INDEPENDENT HEARING AND ASSESSMENT PANEL
CONCEPT PLAN FOR CATHERINE HILL BAY & GWANDALAN

FINAL REPORT

CATHERINE HILL BAY CLIFF LINE ANALYSIS

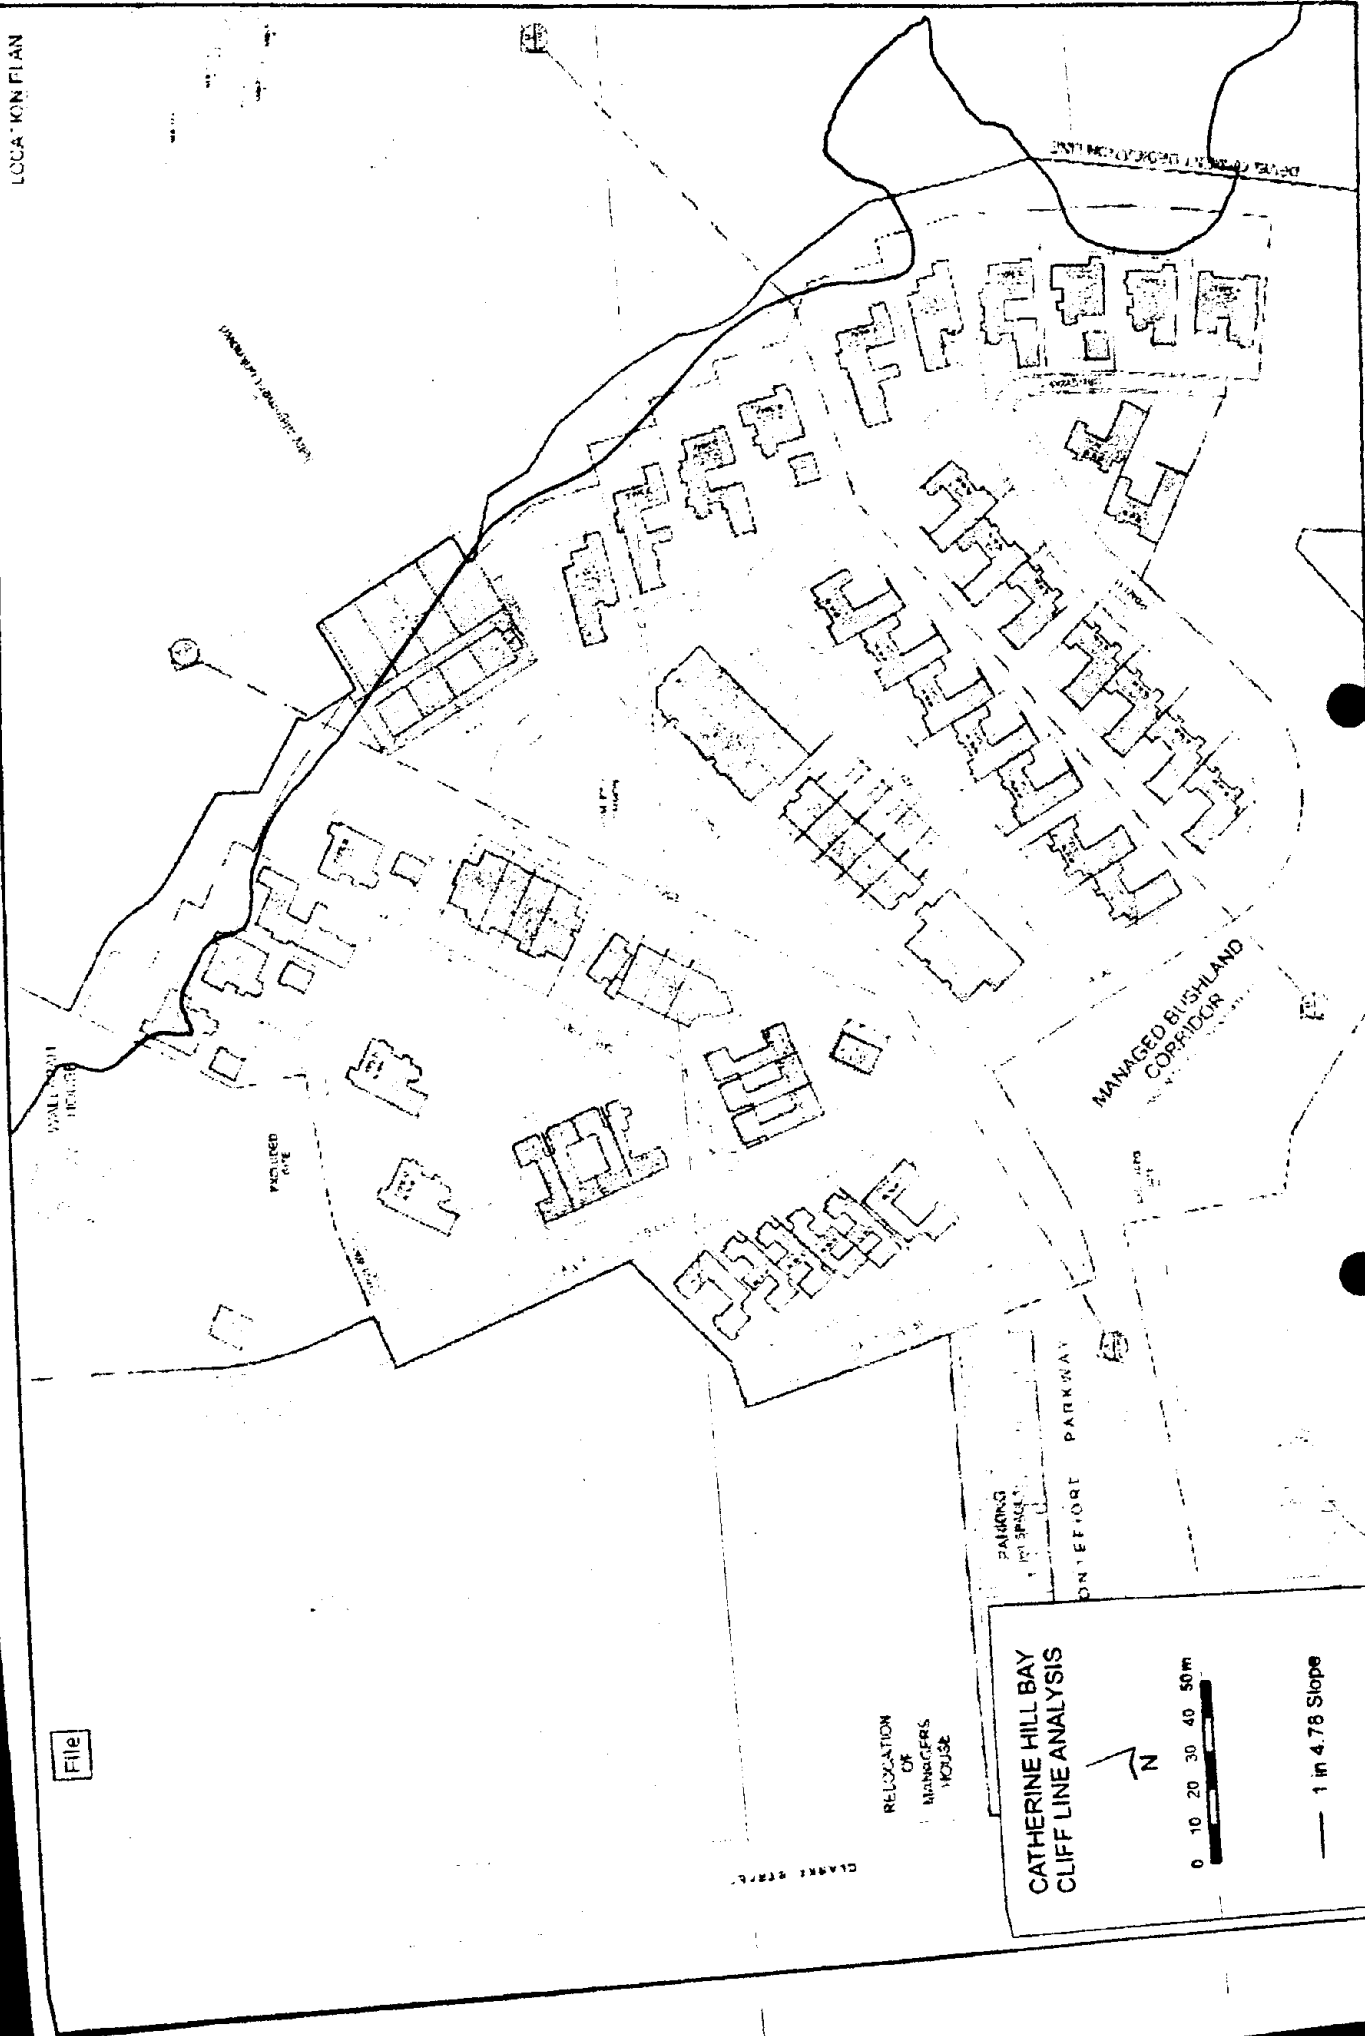
For the purpose of identifying the 25m setback requirement the Panel recommends that the "cliff edge" is defined as the line that represents the point where the land at the cliff edge has a slope of 1 in 4.78 or 20.9% (refer Figure 1 in main body of report).

The cliff line, as defined, is as shown on Figure 1 below.

The Panel is of the view that the proposed coastal walk should be a minimum width of 25m to ensure adequate width for the walk itself and an appropriate setback from the cliff edge to mitigate against cliff retreat, ensure cliff stability etc.

- All development (including proposed allotments) shall be setback a minimum distance of 25m from the cliff edge (with the exception of development associated with the provision of a public lookout and associated small scale café / kiosk on top of the existing Bin Building). If a greater setback is required for cliff stability reasons then this shall be accommodated in the revised design.

It is also considered that dwellings on adjacent allotments should be setback a minimum of 15m from the allotment boundary to ensure visual separation between the coastal walk and private dwellings.
